SERVICE BULLETIN

NO. 1242

RUDDER PEDAL ASSEMBLY INSPECTION

Figure 1
Rudder Pedal Installation (Typical)

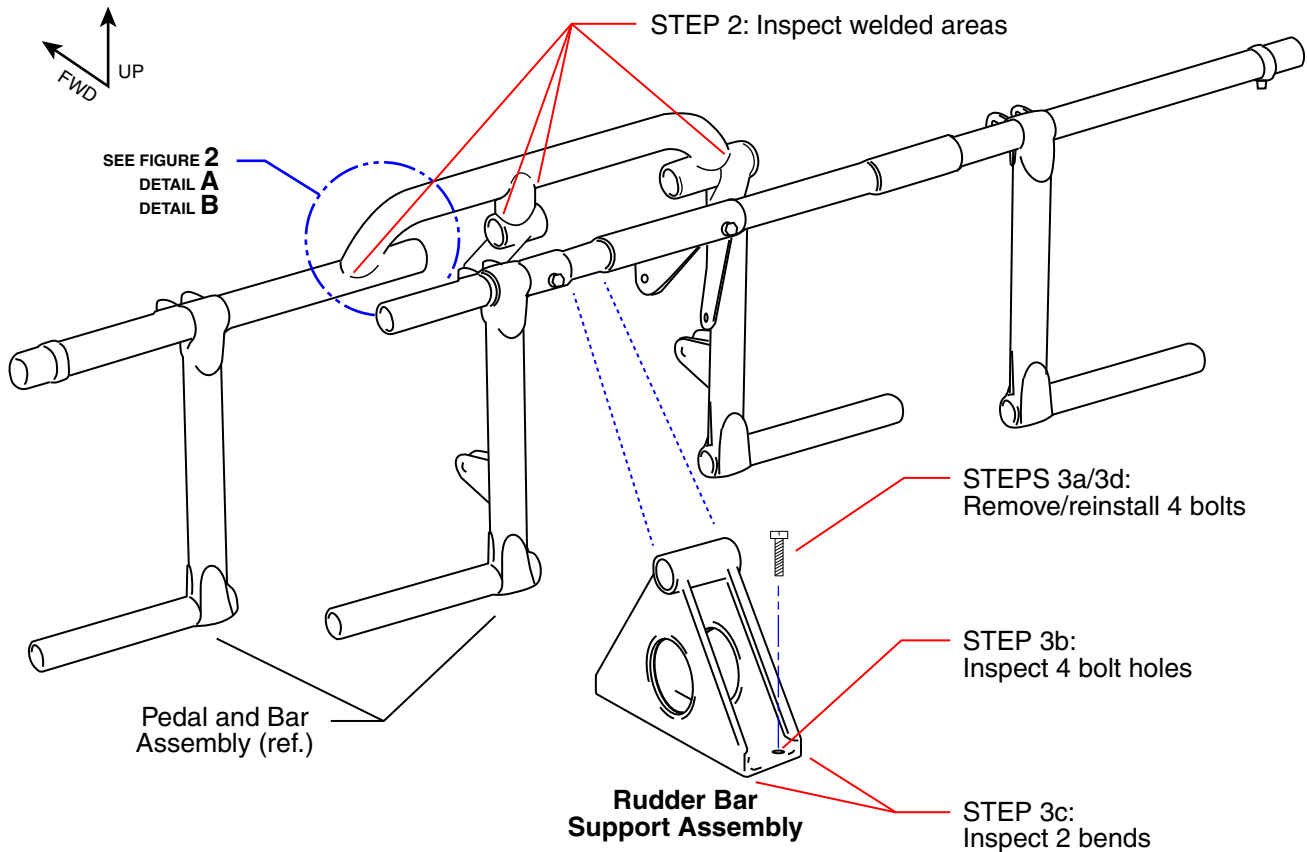
1. Gain access to the areas identified in Figure 1.

Visually inspect all welds, with specific emphasis on the locations identified in Figure 1.

- b. Visually inspect the four (4) bolt holes for cracks and elongation. See Figure 1. The diameter of the four bolt holes should measure 0.250 +0.005/-0.001 inches.
- c. Visually inspect the two (2) sheet metal bends common to the base for cracking, the entire length of each bend, both inner and outer surfaces. See Figure 1.
- d. Reinstall the four (4) bolts that secure the rudder bar support assembly to the cockpit floor. Refer to the appropriate section or chapter of the applicable Piper maintenance manual for the required installation torque for threaded fasteners.

Figure 2
Rudder Bar Welding (Typical)

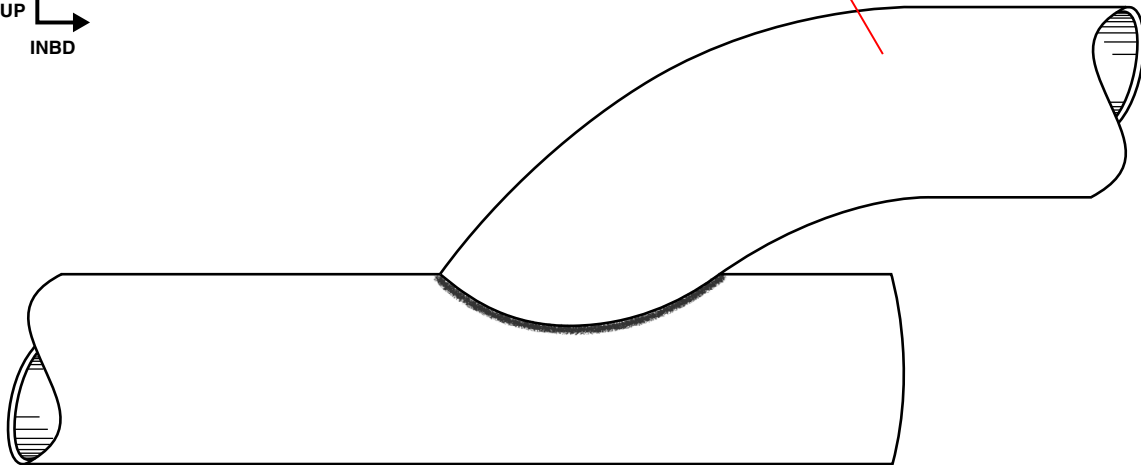
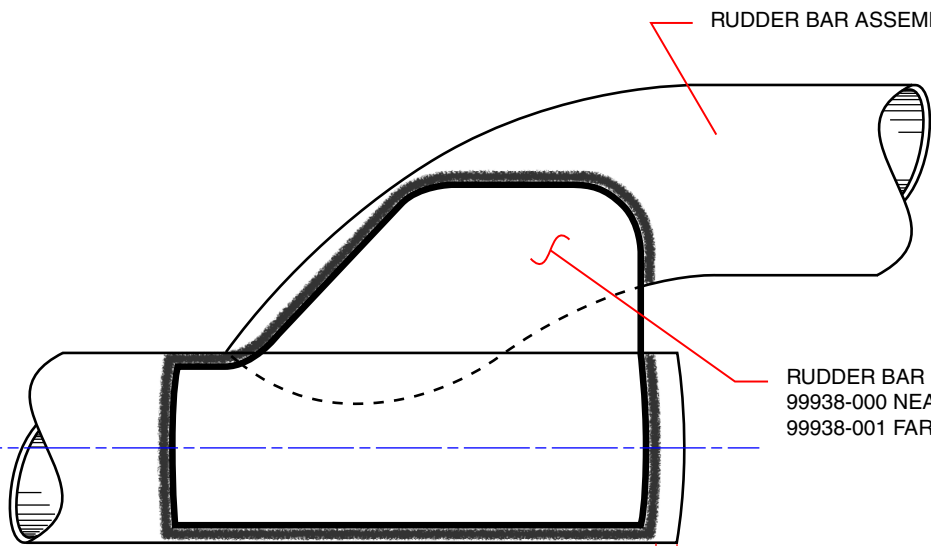
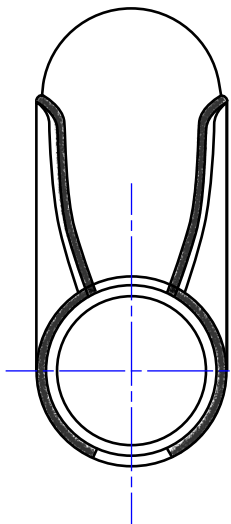
- Examine the area identified in Figures 1 and 2 to determine which rudder bar assembly configuration is installed on the airplane.
 - If the rudder bar assembly conforms to Figure 2, Detail B, the airplane is already in compliance with Service Letter (SL) 671, and/or a replacement rudder bar assembly has been installed which includes these features. No modification is required. Proceed to Part II.
 - If the rudder bar assembly conforms to Figure 2, Detail A, modification is required. Proceed to Step 2, below.

NOTE: All new replacement rudder bar assemblies conform to the configuration shown in Detail B. At the operator's discretion, a new replacement rudder bar assembly may be installed in lieu of the modification described below.

- Examine the area to be modified for cracks, using the inspection criteria described in Part II. Any cracked components must be replaced prior to proceeding.
- Order one each of Piper part numbers (P/N) 99938-000 and 99938-001 rudder bar straps. TIG weld in place as shown in Detail B, per Chapter 4 of AC 43.13-1B (or latest revision). After welding, relieve residual stress in the affected area: Heat with a non-carburizing torch flame to 1,000°–1,100° F (538°–593° C) (a brown red color) then air cool to room temperature. All welding must be performed by a certified welder.

- All materials are 4130 normalized steel.
- The rudder bar tubes have a nominal outside diameter of 0.875 inches and nominal wall thickness of 0.058 inches.
- P/N 99938-000 and 99938-001 rudder bar straps are made from sheet steel with a nominal thickness of 0.040 inches.
